SUB-COMMITTEE ON FIRE PROTECTION  
50th session  
Agenda item 21

FP 50/21  
15 February 2006  
Original: ENGLISH

## REPORT TO THE MARITIME SAFETY COMMITTEE

**Figure 4 – Stretcher dimensions**

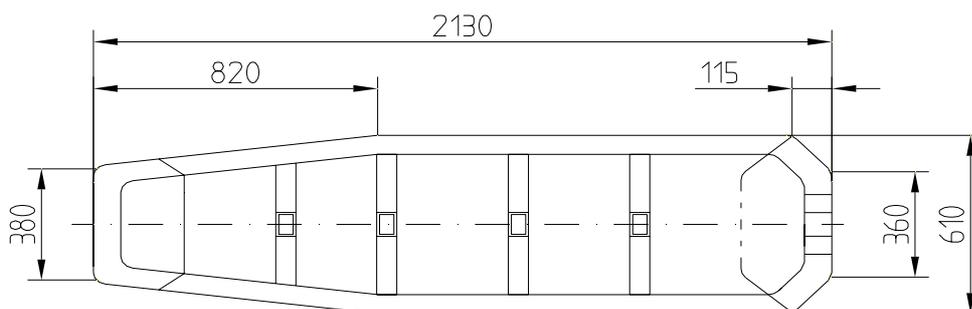
24 In paragraph 7.1.3, in the second sentence, the words “on a stretcher of similar dimensions to those shown in figure 4” are inserted between the words “lie down” and “and the others” and the following figure is inserted after the paragraph:
